ONR Assessment Report

Generic Design Assessment of the BWRX-300 – Step 2 Assessment of Cyber Security

Assessment report reference: AR-01359

Figure 1. Outline of the RP's Cyber Security Risk Assessment Methodology

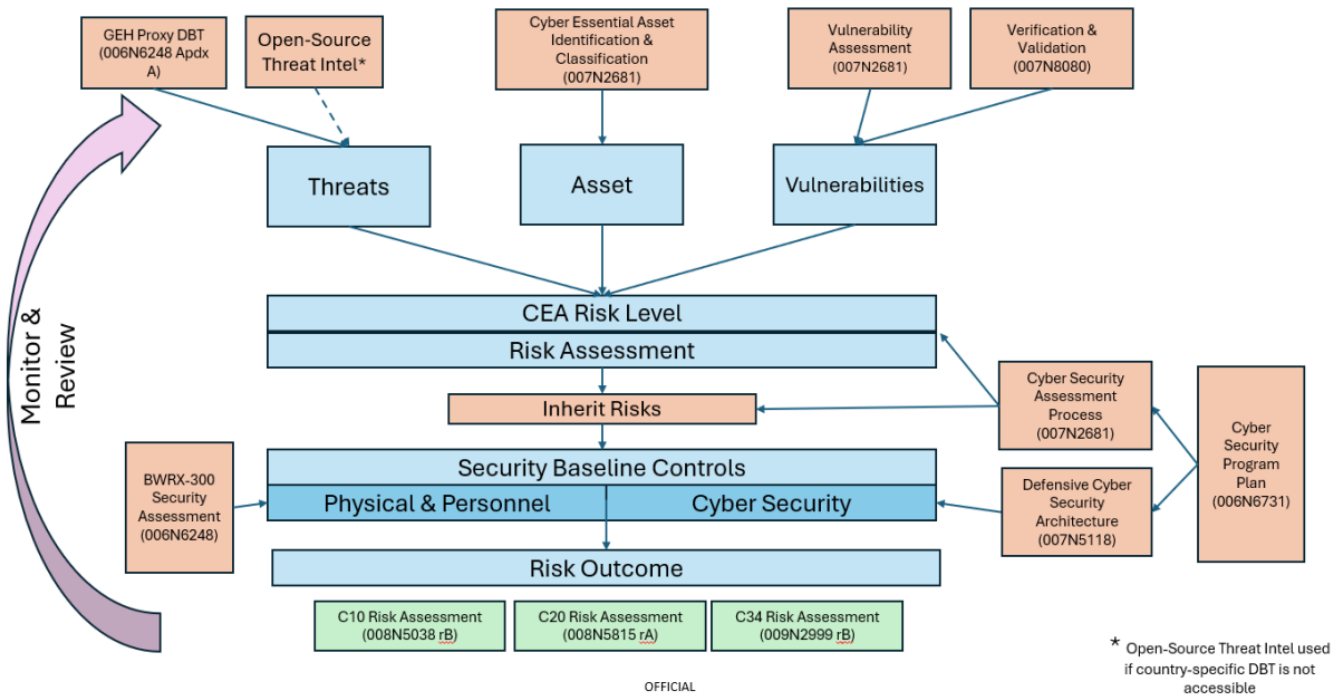
96. The RP submitted Figure 1. which outlines the RP's cyber security risk assessment methodology, referencing key documents.
